Access Compliance Report

Public Rights-of-Way

(Curb Ramps)

Intersection ID: 42742	Main Street: MACANTHRA_DR	Cross Street: LEES_CROSSING_DR	Location: E
ADA ID: C0FEFEEB88A0	Ramp Type: PerpDiag	Initial Pass/Fail: Fail	Overall Compliance: No
Severity Score: 8.75			
Codes/Mitigation Info/Possible Solution		Field Measurements/Component Compliance

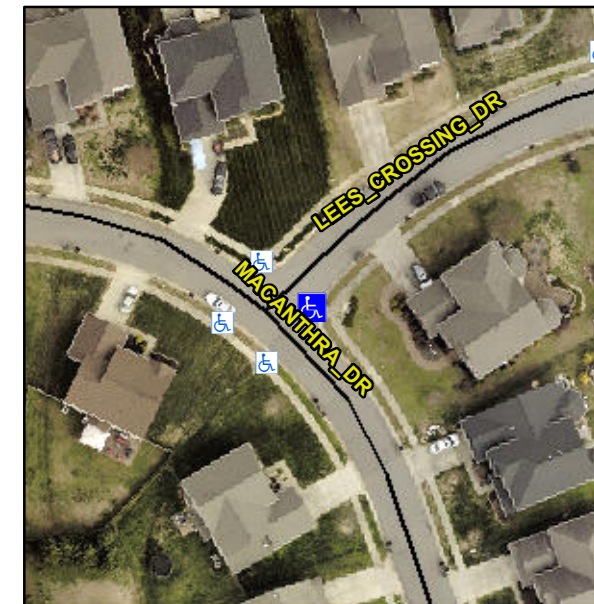
Compliance	Description	Data	Compliance	Description	Data
N/A	Ramp Length (in)	49.5	Yes	Ramp Slope (%)	7.6
No	Ramp Width (in)	47.0	Yes	Ramp XSlope (%)	1.8
N/A	Flare Type LT	N/A	N/A	Flare Type RT	N/A
N/A	Flare Slope LT (%)	N/A	N/A	Flare Slope RT (%)	N/A
N/A	Flare Traversable LT?	N/A	N/A	Flare Traversable RT?	N/A
N/A	Landing Length (in)	N/A	N/A	DWS Provided?	N/A
N/A	Landing Width (in)	N/A	N/A	DWS Contrast?	N/A
N/A	Landing Slope (%)	N/A	N/A	DWS Length (in)	N/A
N/A	Landing X Slope (%)	N/A	N/A	DWS Full Width?	N/A
N/A	Landing Curb? (Y/N)	N/A	N/A	DWS Offset (in)	N/A
N/A	Shared Landing?	N/A			
N/A	Gutter Ponding?	N/A	N/A	Gutter Slope (%)	N/A
N/A	Gutter Lip Ht (in)	N/A	N/A	Gutter X Slope (%)	N/A
N/A	Painted X Walk1?	No	N/A	Painted X Walk2?	No
	X Walk 1 Direction	To N		X Walk 2 Direction	To W
N/A	X Walk 1 Width (in)	N/A	N/A	X Walk 2 Width (in)	N/A
	X Walk 1 Slope (%)	5.1		X Walk 2 Slope (%)	7.4
	X Walk 1 X Slope (%)	3.1		X Walk 2 X Slope (%)	1.8

Remove & Replace Curb Ramp With Two New Directional Ramps or Equivalent.
